SERVICE BULLETIN SUMMARY

TITLE: AIR CONDITIONING - FLOW CONTROL AND INDICATING - INTRODUCE MODIFIED

AIR CONDITIONING FOR EVALUATION

6 DATE : Feb 24/98 SERVICE BULLETIN No. : A320-21-1906

Removal/Installation of the Pack Controller Figure 1 Sheet 1

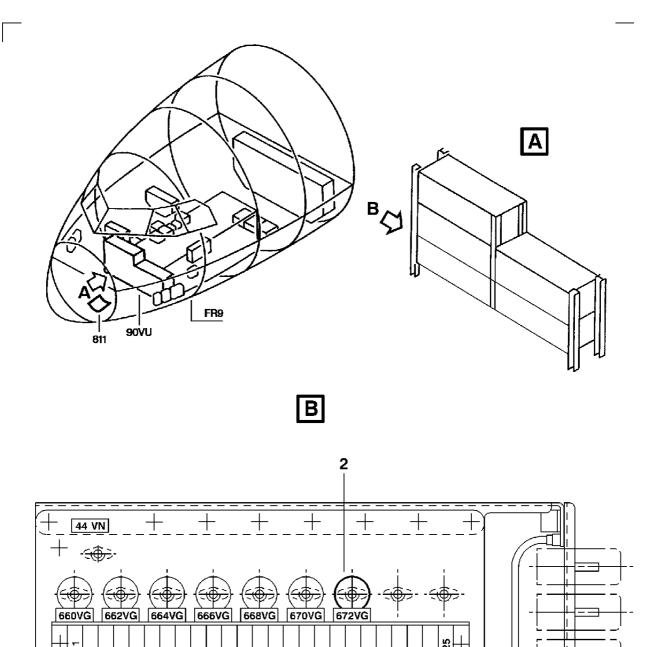
(1) Remove the pack controller in the electronics rack 90VU

1	pack controller	7HH	759A0000-10	Item (1)	Retain
	or

- 1 pack controller 7HH 759C0000-02 Item (1) Retain and
- 1 pack controller 27HH 759A0000-10 Item (1) Retain or
- 1 pack controller 27HH 759C0000-02 Item (1) Retain
- (2) Modify the wiring and the equipment in the shelves 95VU and 96VU Refer to Figure 2 , 3 and 4
 - (a) Install except for aircraft MSN 588, 612, 621, 629, 713, 727 and 734, in the shelf 96VU:

(3)	Install the new p	ack controlle	r in the electron	nics rack 90VU	:
	Refer to AMM: 21	-61-34, P. Blo	ock 401		
1	pack controller	7HH	75900000-01	Item 1	
	or				
1	pack controller	27нн	75900000-01	Item 1

Removal of the Flow Control Valves and Pressure Sensors Figure 5 Sheet 1

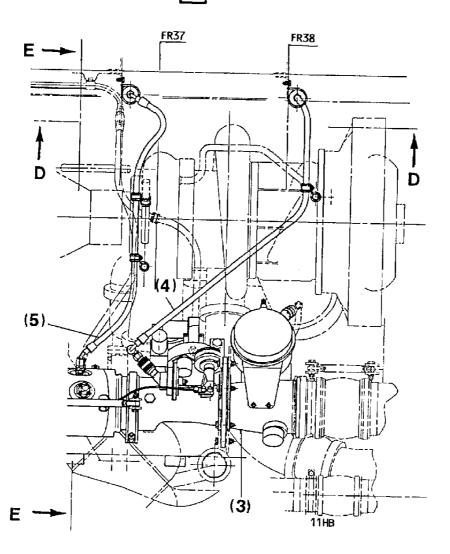
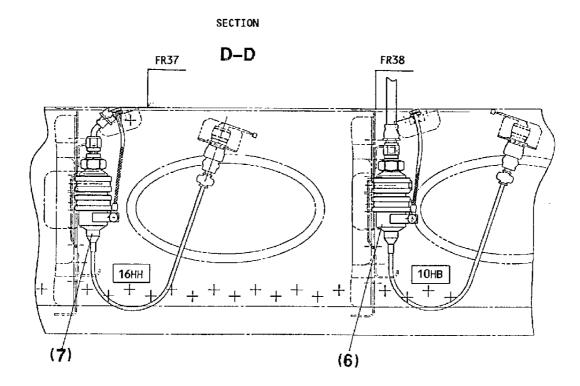
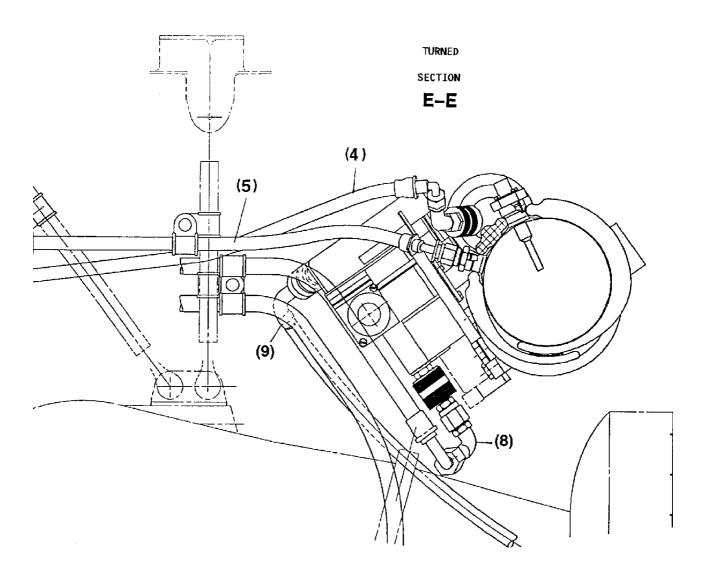
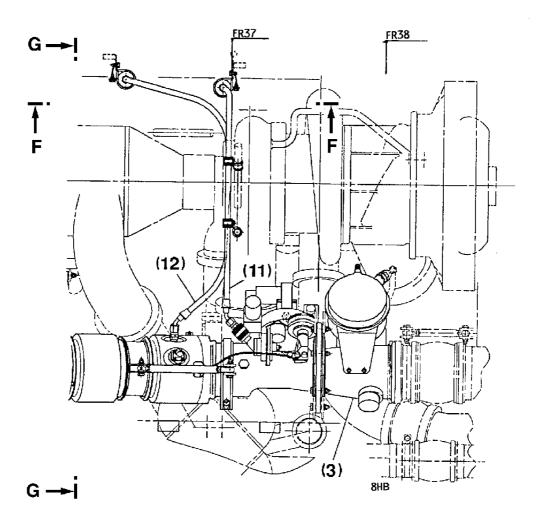
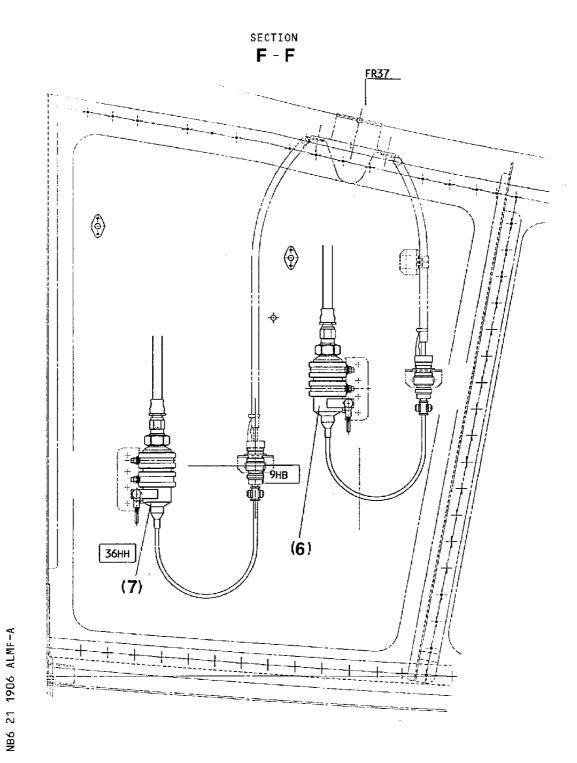
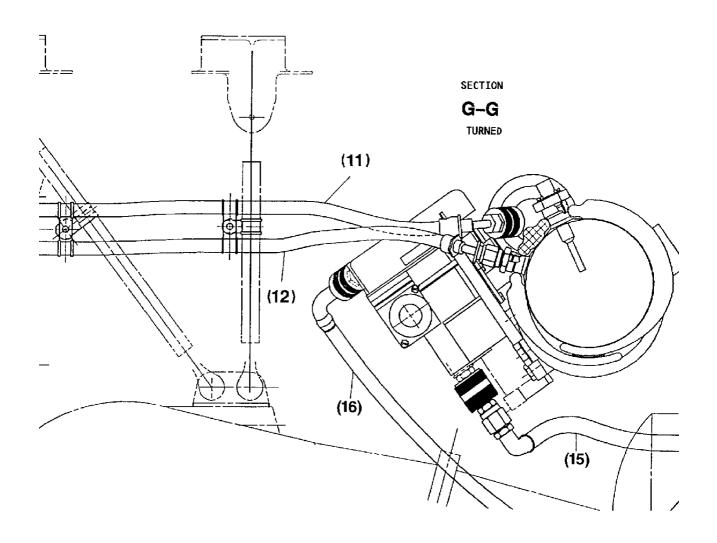
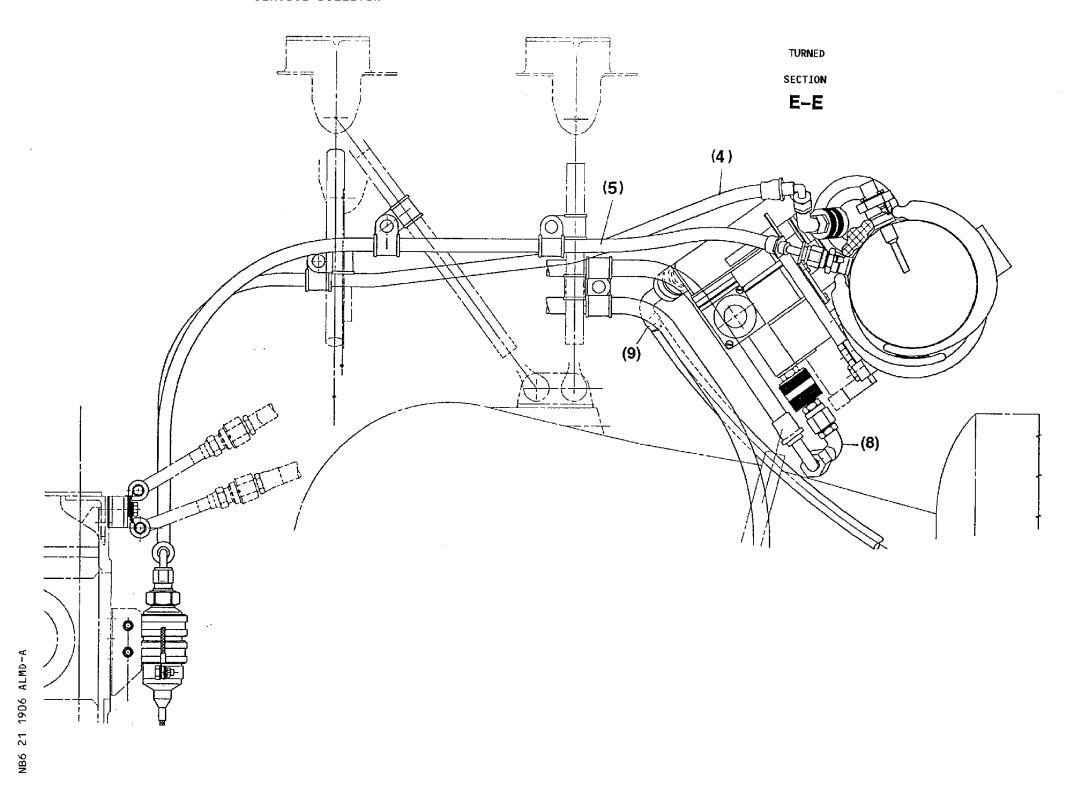
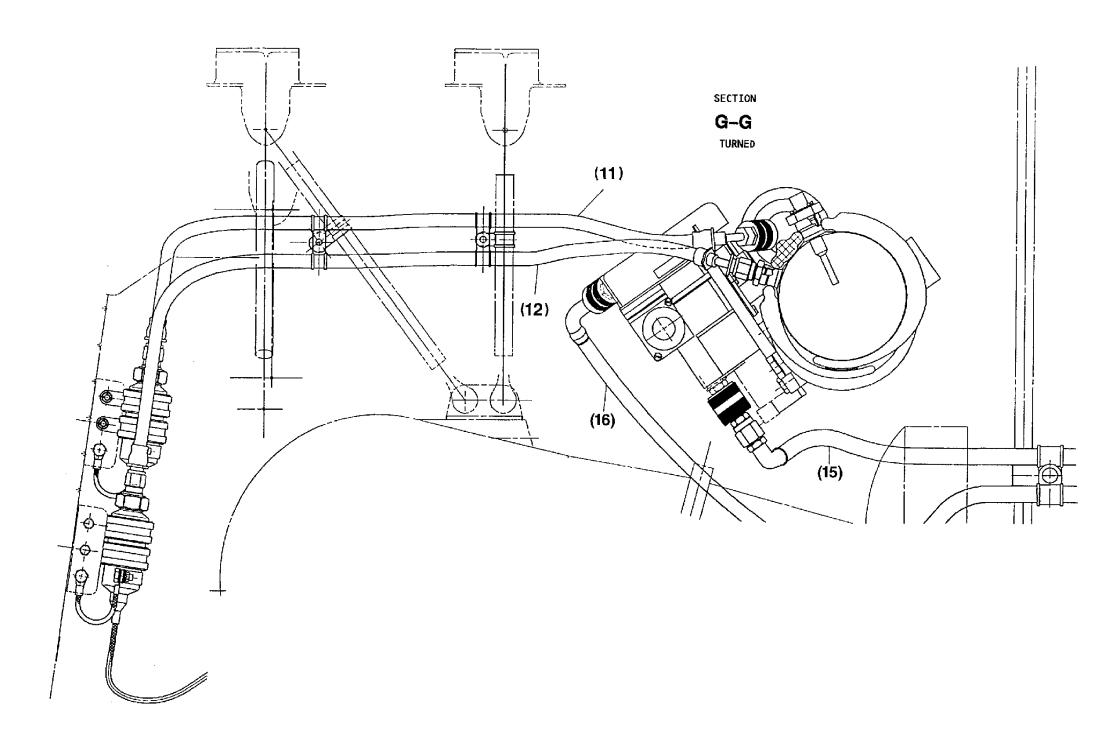
(4)	Remove the flow c		in the zones 19°	1 or 192	
	Refer to Figure 5				
	Refer to AMM: 21		ock 401		
		,			
1	flow ctr valve	8HB	751A0000-07	Item (3)	Retain
	or				
1	flow ctr valve	8нв	751B0000-02	Item (3)	Retain
1	and	опь	73160000-02	rtem (3)	Ketaiii
	anu				
4	£1	4440	75440000 07	T+ /7\	D-4-10
1	flow ctr valve	11HB	751A0000-07	Item (3)	Retain

1	flow ctr valve	11HB	751B0000-02	Item (3)	Retain
		the hoses with	h the items giver	n in the figu	re to
(5)				400	
(5)	Remove the pressur	e sensors in	the zones 191 or	192	
	Refer to Figure 5				
	Refer to AMM: 21-	51-11, P. Blo	ck 401		
1	pressure sensor	9нв	9104A0003-01	Item (6)	Retain
	or				
1		1000	010/40007 01	Item (6)	Datain
ı	pressure sensor		9104A0003-01	Item (6)	Retain
	Refer to AMM: 21-	61-16, P. Blo	ock 401		
1	pressure sensor	16HH	768A0000-03	Item (7)	Retain
	or				
1	pressure sensor	36HH	768A0000-03	Item (7)	Retain

Installation of the Flow Control Valves and Pressure Sensors
Figure 6 Sheet 1

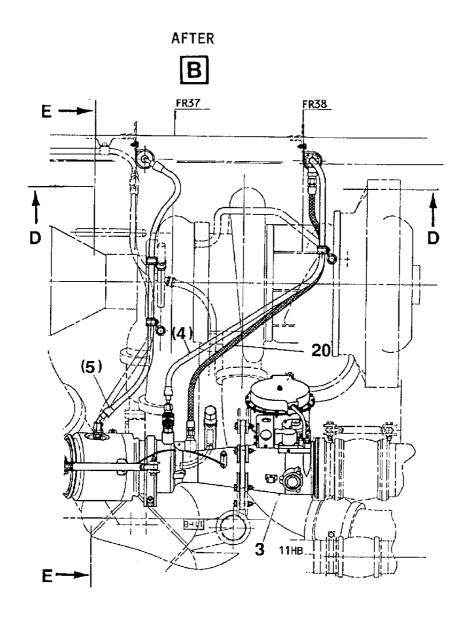
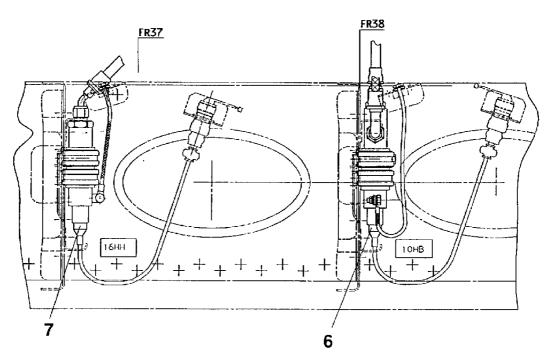
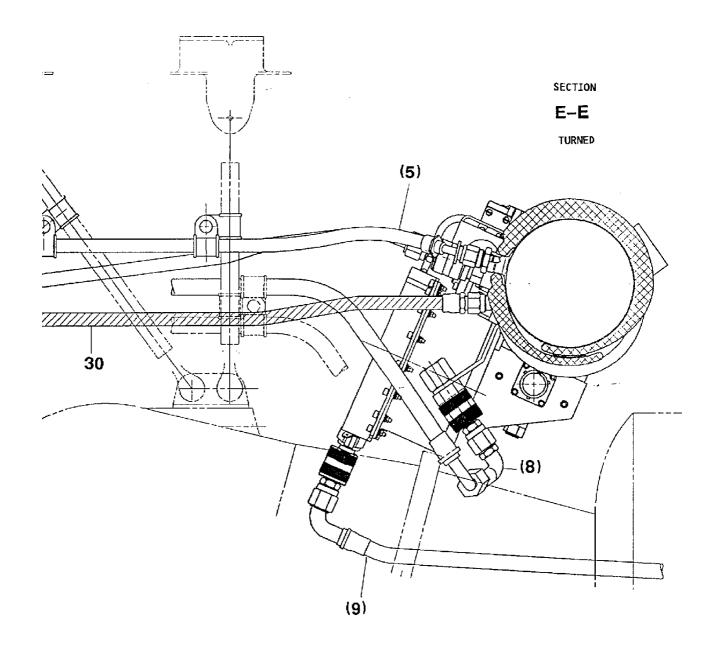
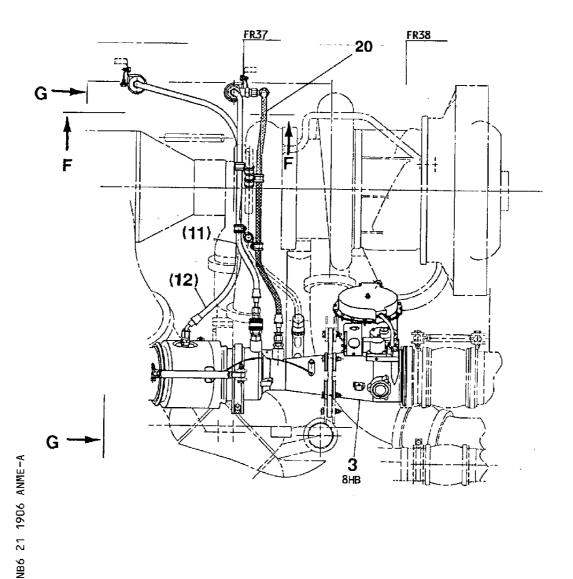
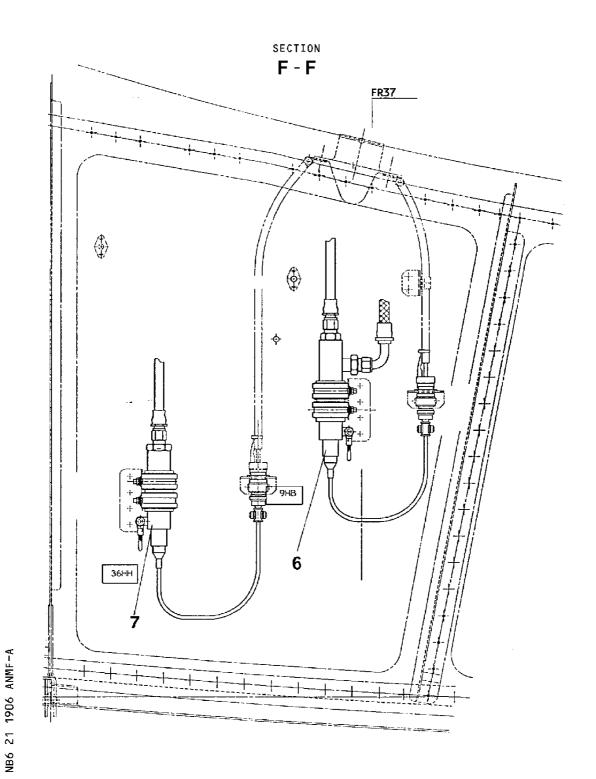
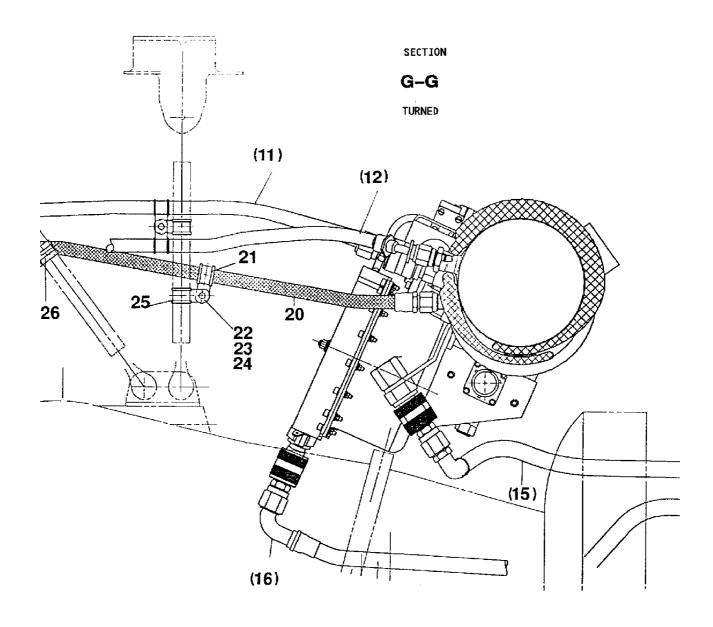
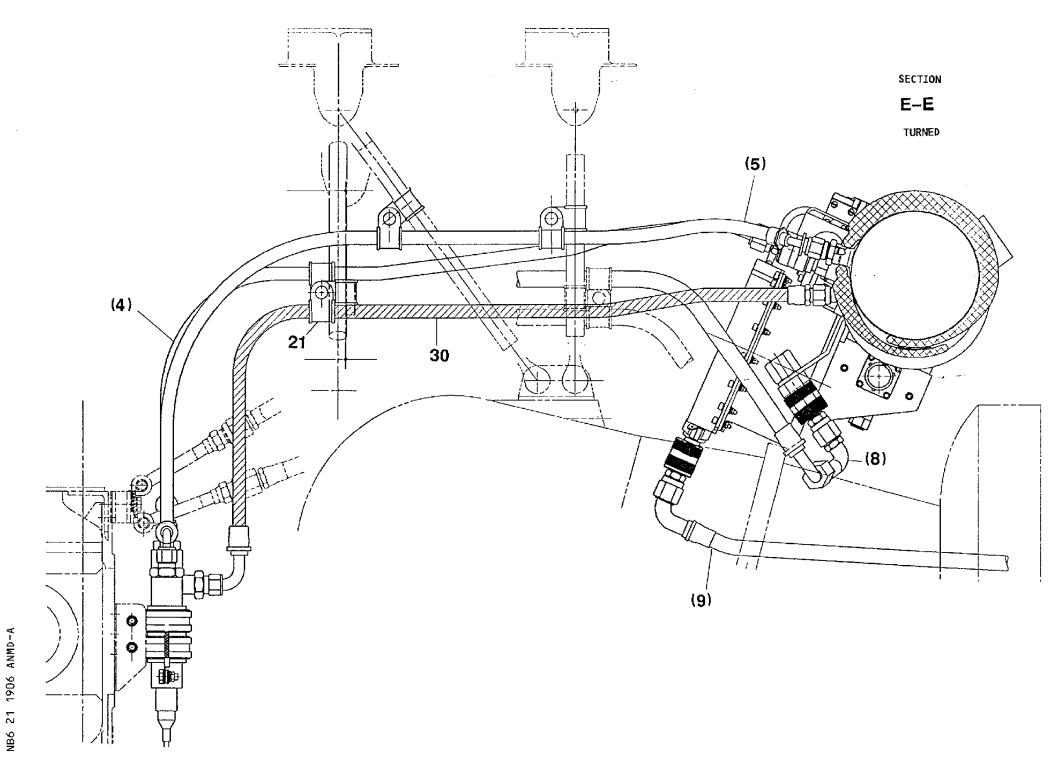
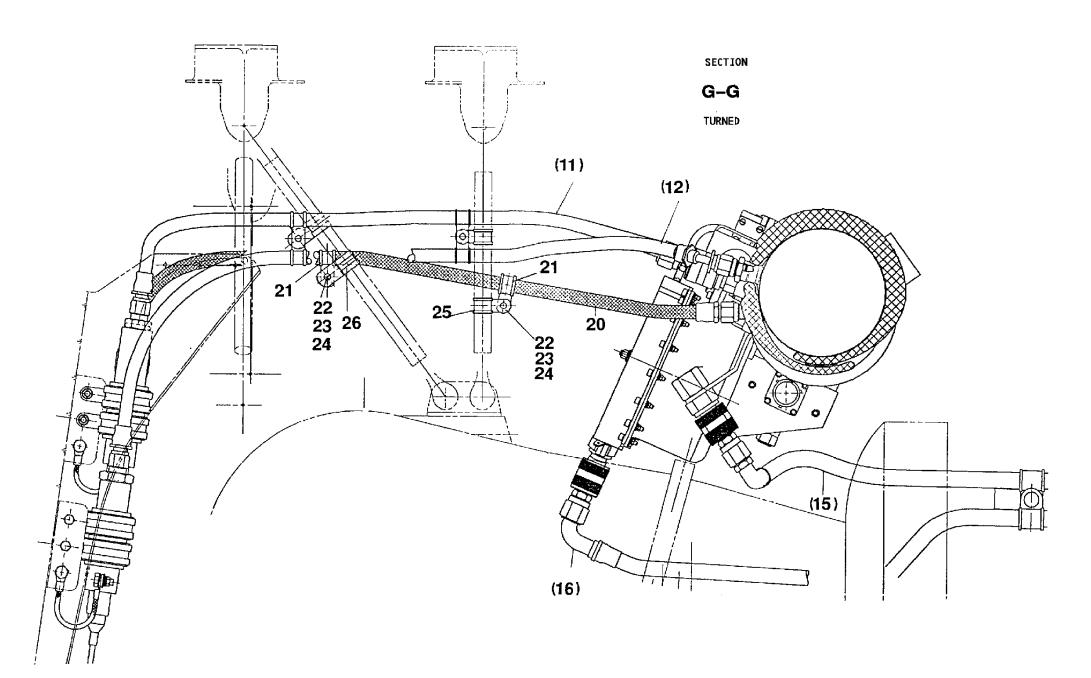
(6)	Install the new pr	essure sensor	s in the zones 1	91 or 192	
	Refer to Figure 6				
	Refer to AMM: 21-	51-11. P. Blo	ock 401		
	Kerer to Allin 21) , bec	70K 101		
1	pressure sensor	9НВ	9106A0005-01	Item 6	
	or				
1	pressure sensor	10HB	9106A0005-01	Item 6	
	Refer to AMM: 21-	61-16, P. Blo	ck 401		
1	pressure sensor	16нн	9104A0006-01	Item 7	
ı		101111	7104A0000-01	T C III I	
	or				
1	pressure sensor	36нн	9104A0006-01	Item 7	
<i>(</i> - <i>)</i>			404

(7) Install the new hose on LH side, zone 191

(a)	Put	the	hose	in	position	and	connect	to	the	pressure	sensor
	10HE	3, it	tem 6	:

(b) Install the Hose, item 30, as shown section G-G with:

(8) Install the new hose on RH side, zone 192

(a) Put the hose in position and connect to the pressure sensor 9HB, item 6:

(b) Install the Hose, item 20, as shown section E-E with:

(9) Install the new flow control valves in the zone 191 or 192
Refer to Figure 6

1 flow ctr valve 8HB 1303A0000-01 Item 3 or

1 flow ctr valve 11HB 1303A0000-01 Item 3

NOTE: Connect the hoses as shown in the figure.
